To: The Commissioners of the CNSC
From: Gordon Edwards, Ph.D.
Date: December 9 2012

Re: The Unavailability of CANDU safety systems

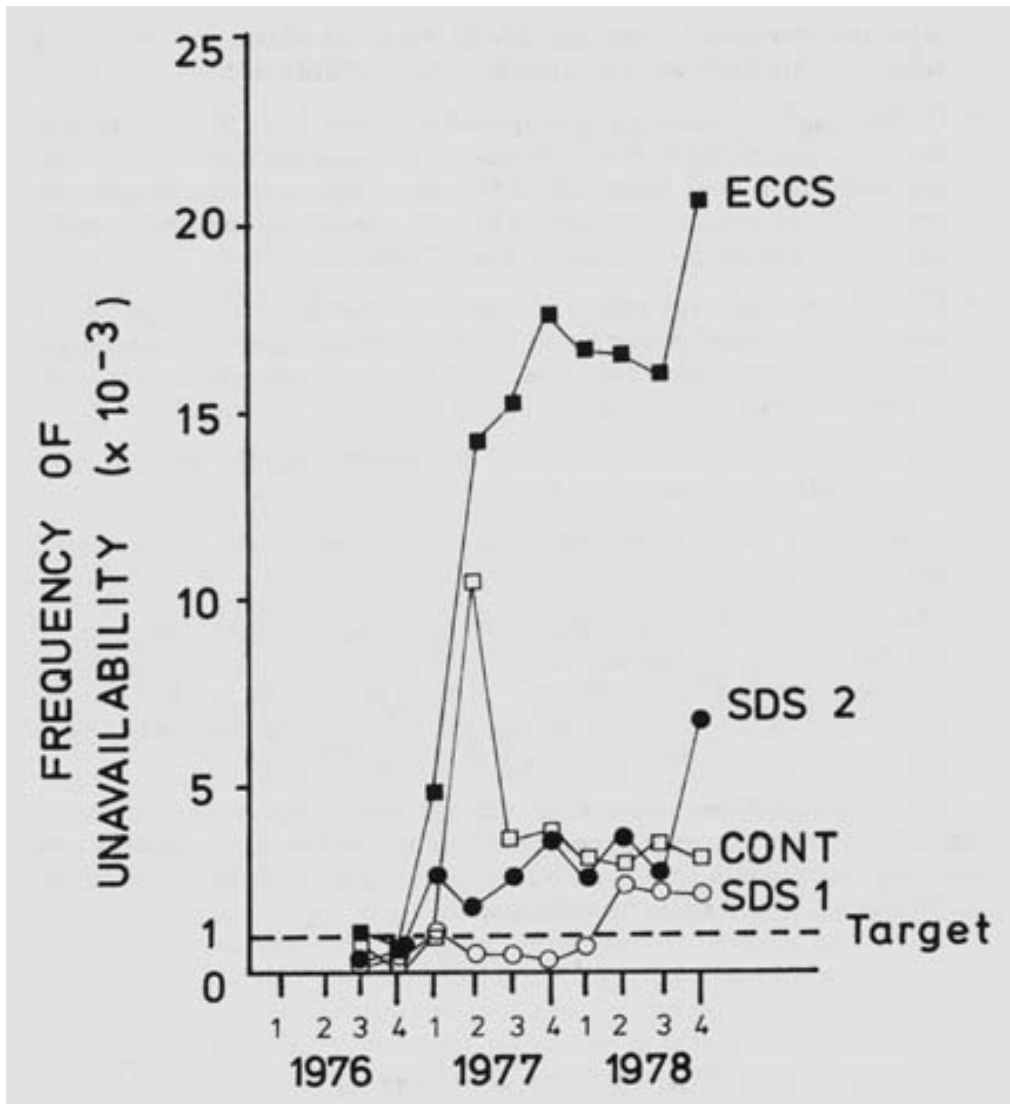
As Mr. Jammal confirmed during the December 9 hearings, the target unavailability of each of these four safety systems, as prescribed by the regulator, is 10^{-3} or 1 in 1000. In practical terms, this means that each year, each safety system is assumed to be unavailable no more than 7 hours per year, based on an 80% capacity factor.

As it happens, in the last three quarters of 1978 none of the four safety systems at Bruce “A” met this target. ECCS, for example, was unavailable for 39 hours during the fourth quarter of 1978; that is more than 22 times above the target (i.e. $7/4 = 1.75$ hours per quarter). In addition, 3 of the 4 Bruce “A” safety systems failed to meet the target in each of the four quarters of the year 1977 (as well as each of the four quarters of 1978).

Such data have important repercussions for the credibility of any Probabilistic Safety Analysis. For example, if the probability of a Loss of Coolant Accident (LOCA) is assumed to be 1 in 100 for a small pipe break, and the probability of no Emergency Cooling is assumed to be 1 in 1000, then the probability of a LOCA with no ECCS may be calculated to be 1 in 100,000 per year. But if ECCS is unavailable 22 times more often than assumed, the probability of this accident is 1 in 4,550 per year – much higher!
